SERVICE BULLETIN

Bulletin No. 04-11
July 8, 2011

Subject: Enhancement of Vector Corded Low Pressure Barrels

Figure 1 View of Insert

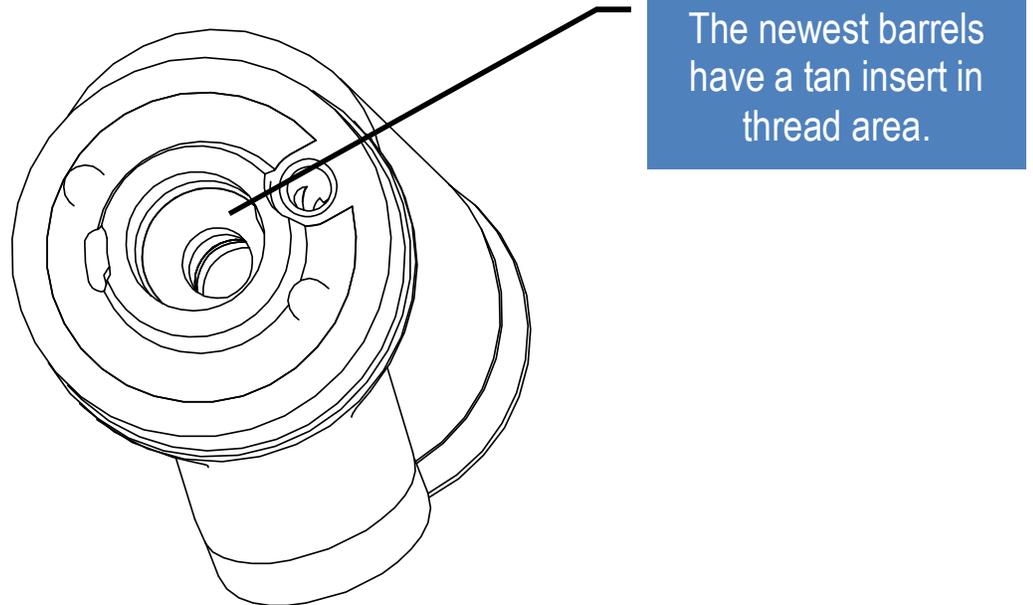
To enhance the performance of the Vector Corded low pressure barrels, an insert has been added in the following barrels:

To identify the new barrels, look in the front of the barrel for the tan front nose of the barrel. See figure 1 for an illustration.
